Improving the CR loss budget

Piers Dawe, Nvidia

Comment 92, improve the CR loss allocations

Example of switch PCB losses

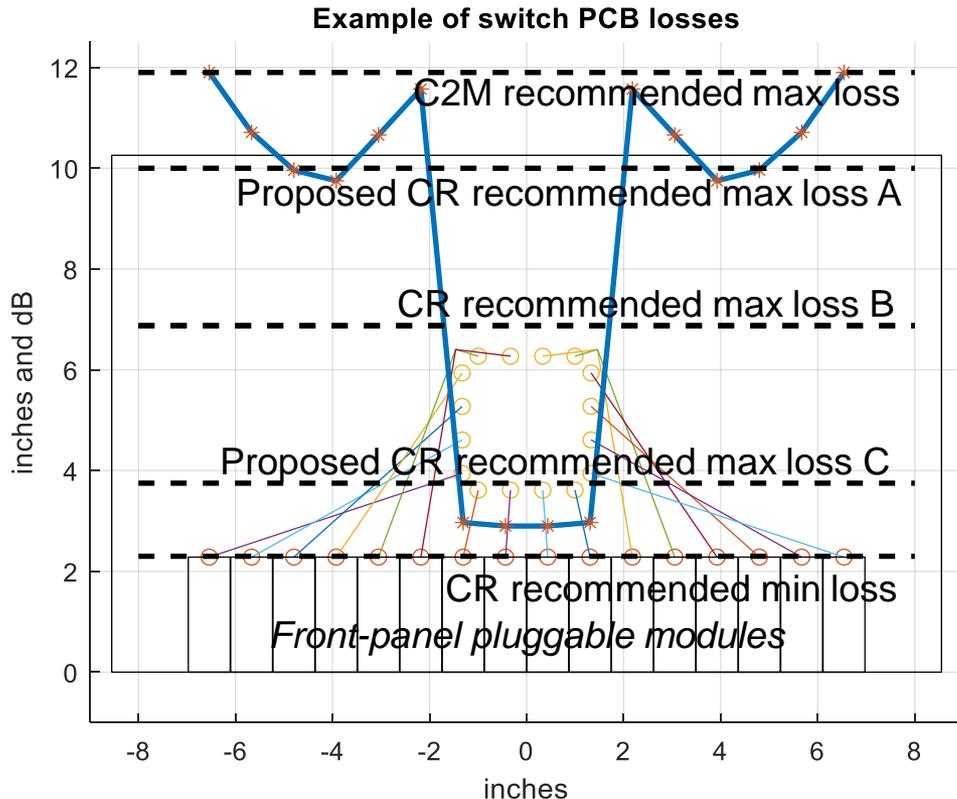
6.875/2.3 = 3:1 is too small a max/min loss ratio anyway

At 25G/lane and 50 G/lane we had 5.8:1

Want at least about 4:1. This example 4.1:1

- In this example, all paths are below the C2M recommended max loss (good)
- But only 8 out of 32 are within the CR recommended max loss (bad)
- Other distributions are possible (see next slide) but the issue remains
- There are fixes (see e.g. [2]) but with costs

Another example of switch PCB losses

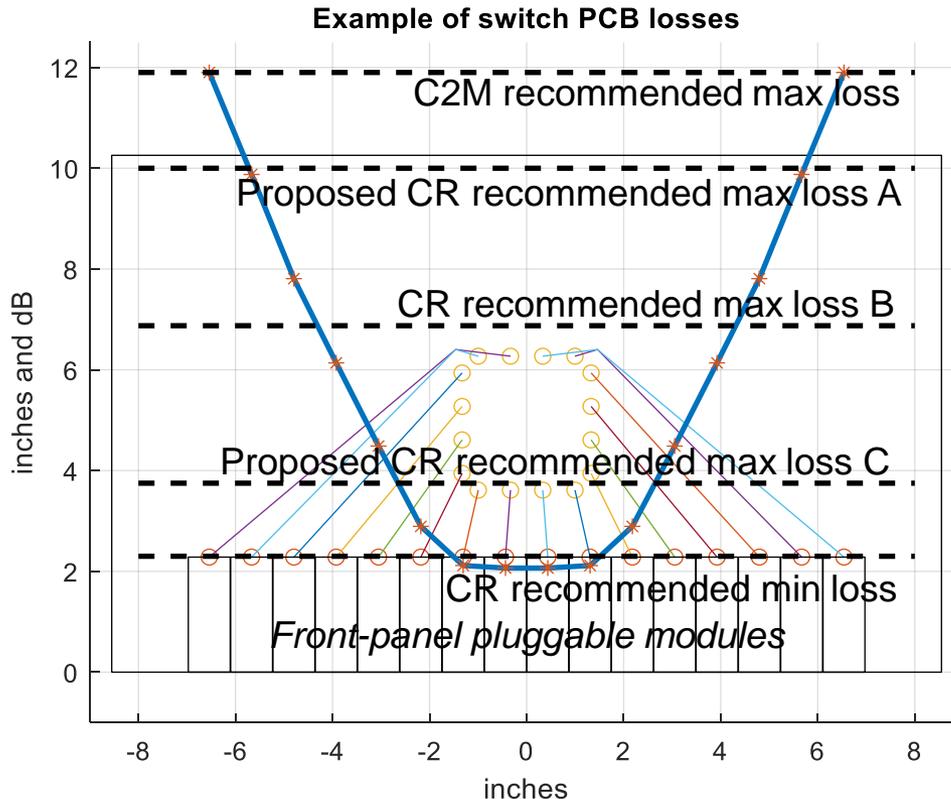
6.875/2.3 = 3:1 is too small a max/min loss ratio anyway

At 25G/lane and 50 G/lane we had 5.8:1

Want at least about 4:1. This example 5.8:1

- In this example, all paths are below the C2M recommended max loss but it needs lower loss/in than previous example
- But only 10 out of 32 are within the CR recommended max loss (bad)
- 4 paths are below the C2M recommended minimum
- There are fixes (see e.g. [2]) but with costs

NIC losses

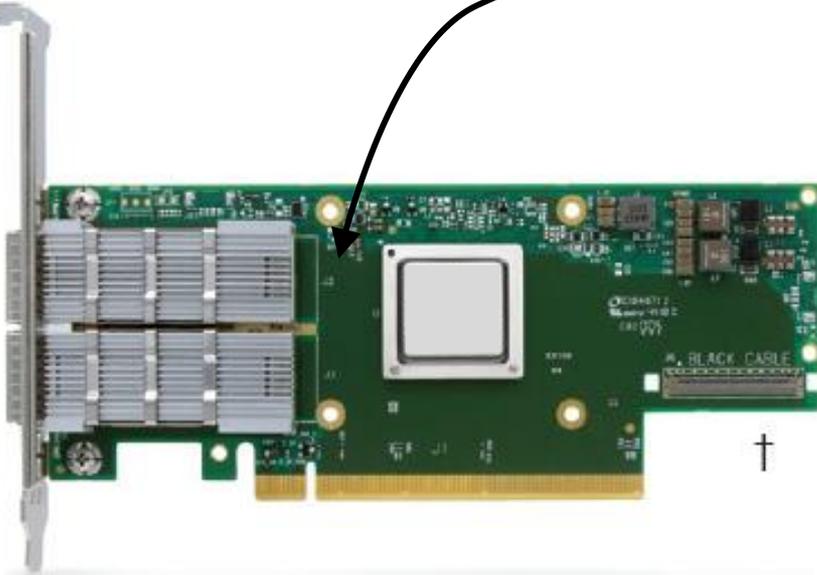
*See comments 92 and 93
(reproduced later in this slide pack)*

In the future, some LAN-on-motherboard (LOM) servers (different to NICs) could find the 6.875 dB allocation convenient

- IC to module length is typically short
 - More in reference [3]
- PCIe card is much smaller than switch card, but there are many more of them
- For both reasons, trace loss in dB/in is higher for NIC than switch
- But length wins: less loss is needed than in switch
- 3.75 dB is enough for the NIC
- **>3 dB spare** to give to the switch
 - 3.125 dB re-allocated in this proposal, a little more might be possible
- There are very few ports in a NIC and the host trace losses can be similar to each other, unlike in a switch
- Losses < CR recommended minimum would be natural

Figure 162A-3—Cable assembly, host, and test fixture insertion loss at 26.56 GHz

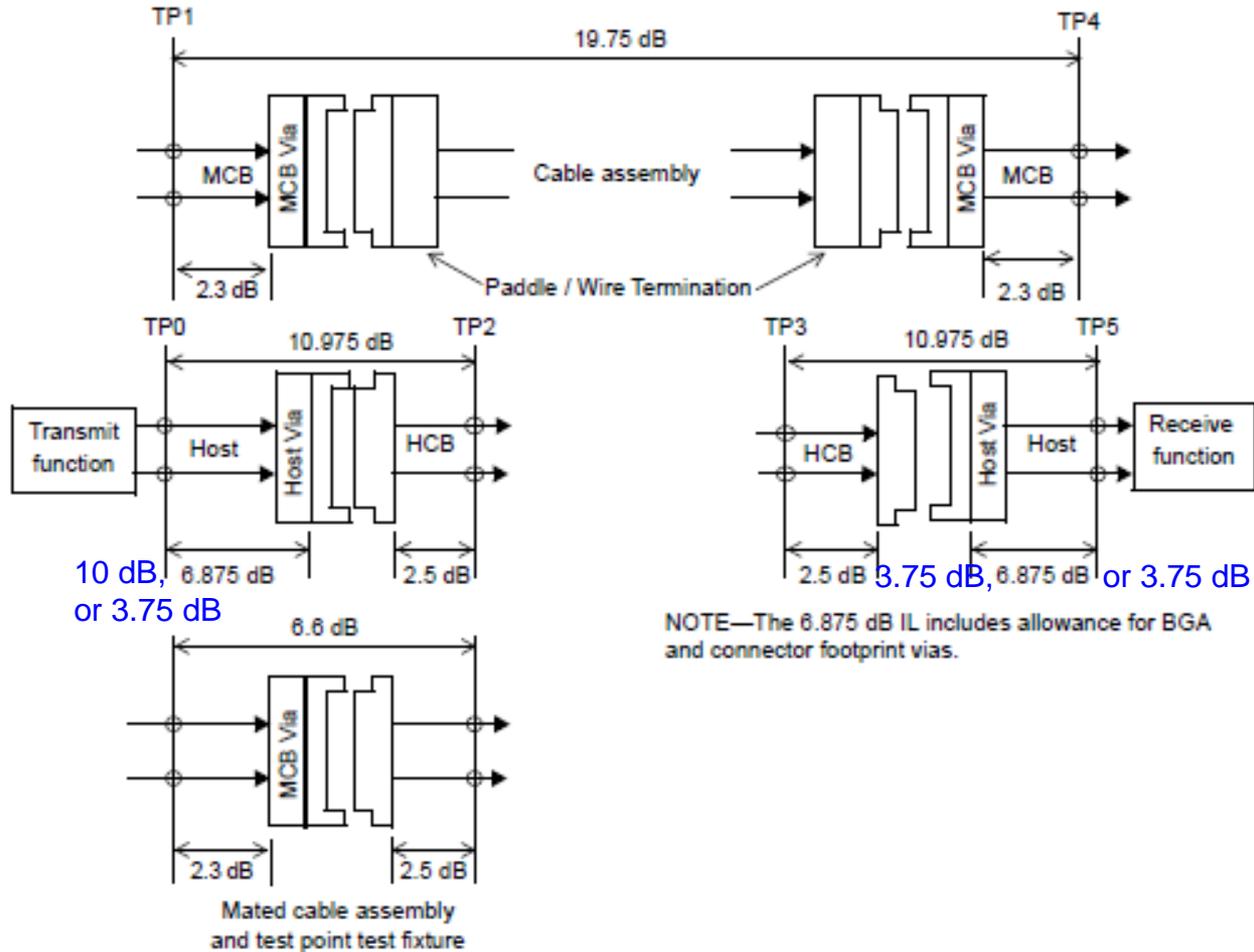
- In Table 162-10, add limits A and C for linear fit pulse peak ratio (min), as in next slide
 - Change text in 162.9.3.1.2 to refer to the table
- In Table 162-15, add columns for Test 2 (high loss), A and C, with test channel insertion loss:
 - A: $6.875 - 3.75 = 3.125$ dB lower (20.5 dB to 21.5 dB), and
 - C: $10 - 6.875 = 3.125$ dB higher (26.75 dB to 27.75 dB), as in slide after next
 - No change needed for Test 1 (low loss)
- In 162.11.7.1.2, instead of using $S^{(\text{HOSPR})}$ per 162.11.7.1.1 ($z_p = 110.3$ mm for 4.33 dB), use $z_p = 30.7$ mm for 1.205 dB *Added 14 Jul*
- In 162A.4, add equations for IL_PCBmax and ILHostMax A and C, show them in Fig 162A-1 and 2
- In 162A.5, add Value columns A, C in Table 162A-1 (ILChmin and ILMaxHost differ)
- Adjust figures 162A-3 and 4.

NOTE—2.3 dB MCB PCB IL includes the RF connector (up to the RF connector reference plane). The MCB via allowance is 0.2 dB.

Figure 162A-4 enabling long cable

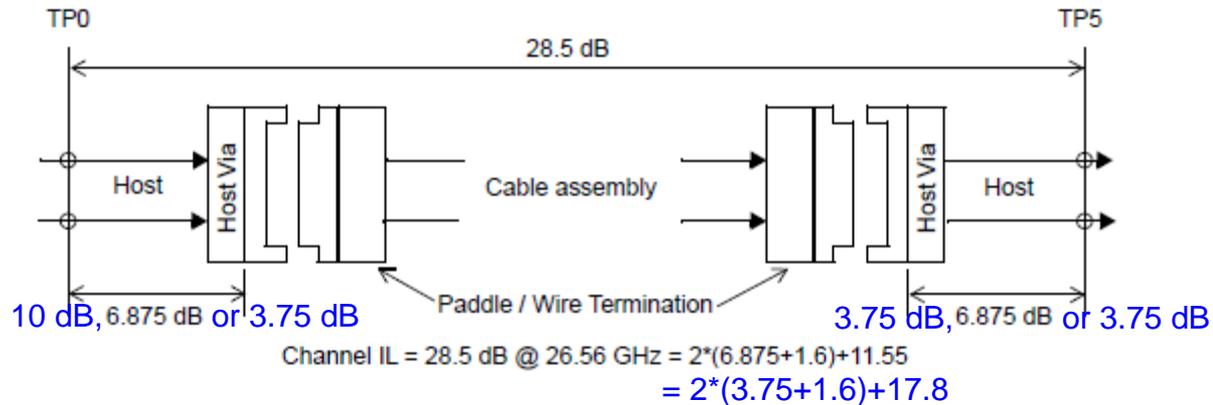
- 2 classes of cable, "short" or regular (19.75 dB, as today) and "long", $19.75 + 2 * (6.875 - 3.75) = 19.75 + 6.25 = 26$ dB max
 - Achievable cable length 3 m
 - A B C hosts could enable a "super short" category too, $19.75 - 6.25 = 13.5$ dB max for A-A links, and intermediate categories: assume that these are not interesting
- Long cables connect port types C at both ends, short cables connect a valid (see earlier) combination of A, B, C
 - Each host knows its loss ability, learns remote loss ability from AN, learns cable loss class from its memory map
- In 162.11.2, cable assembly insertion loss, change text to refer to Table 162-17
- In 162.11.7.1.1, add $z_p = 30.7$ mm for the "long" cable
- In Table 162A-1, add a column for the A-short-A scenario (ILCamax differs) as on next slide
- Figure 162A-3 stays as slide 19, Figure 162A-4 as on slide 24

NOTE—Channel IL derived from cable assembly host, and mated test fixture
